Access Compliance Report

Public Rights-of-Way (Curb Ramps)

Intersection ID: 11231	Main Street: W_4TH_ST_EXT	Cross Street: WALNUT_AV	Location:	N
ADA ID: 833FDF6C6DD4	Ramp Type: Directional1	Initial Pass/Fail: Pass	Overall Compliance: No	Severity Score: 0
Codes/Mitigation Info/Possible Solution		Field Measurements/Component Compliance

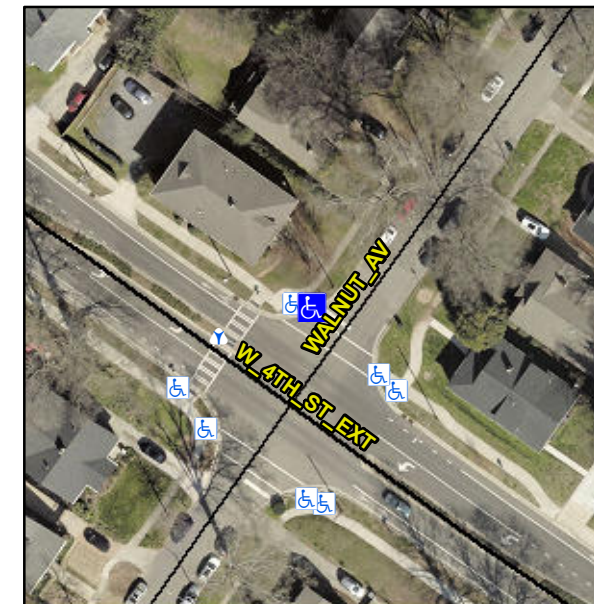
R304.2.1, R304.2.2-Perp, R304.3.2-Para, R304.5.2, R305.2

Compliance	Description	Data	Compliance	Description	Data
N/A	Ramp Length (in)	65.0	No	Grade Break?	No
Yes	Ramp Width (in)	70.5	N/A	Grade Break Slope (%)	N/A
Yes	Ramp Slope (%)	7.3	N/A	Grade Break XSlope (%)	N/A
Yes	Ramp XSlope (%)	1.3			
Yes	Flare Type LT	N/A	Yes	Flare Type RT	N/A
N/A	Flare Slope LT (%)	N/A	N/A	Flare Slope RT (%)	N/A
N/A	Flare Traversable LT?	No	N/A	Flare Traversable RT?	No
No	Landing Length (in)	45.0	Yes	DWS Provided?	Yes
Yes	Landing Width (in)	70.0	Yes	DWS Contrast?	Yes
No	Landing Slope (%)	2.4	Yes	DWS Length (in)	24.0
Yes	Landing X Slope (%)	0.9	Yes	DWS Full Width?	Yes
N/A	Landing Curb? (Y/N)	No	No	DWS Offset LT (in)	N/A
N/A	Shared Landing?	No	No	DWS Offset RT (in)	N/A
Yes	Gutter Ponding?	No	Yes	Gutter Slope (%)	4.6
Yes	Gutter Lip Ht (in)	0.0	Yes	Gutter X Slope (%)	0.0
N/A	Painted X Walk1?	No		Road Slope (%)	1.8
	X Walk 1 Direction	To SE		Road X Slope (%)	0.9
	X Walk 1 Width (in)	N/A		Clear Space?	Yes

X Walk 1 Slope (%)	1.8	N/A	Clear Space to XWalk (in)	N/A
	X Walk 1 X Slope (%)	0.9	Yes	Storm Grate/Utility Hazard?	No
N/A	Ramp inside XWalk1?	N/A		Storm Grate/Utility Type	
Yes	Any Obstructions?	No			N/A
	Obstruction Type		Yes	Surface Condition? (G/P)	Good
			N/A	Curb Slope (%)	6.8

Remove & Replace Entire Ramp.
